Comment for DE-24-087 and SEC 2024-02

**X178-2 Transmission Line Rebuild & OPGW Project Phase 1
Woodstock, Easton, and Sugar Hill, New Hampshire**

Photograph No. 19: Looking westerly at proposed access toward Structure 298.

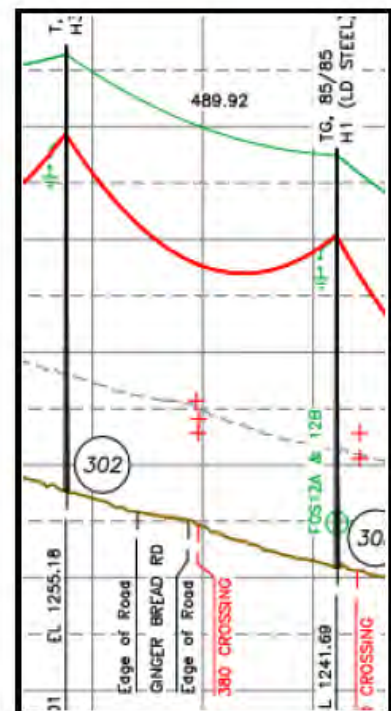
Does the person who lives in the house just left of this structure know that Eversource plans to more than double this structure height, to 79'? The clearance over the road is 25' in excess of what is required by Code.

This subdivision is in former pasture/crop land.
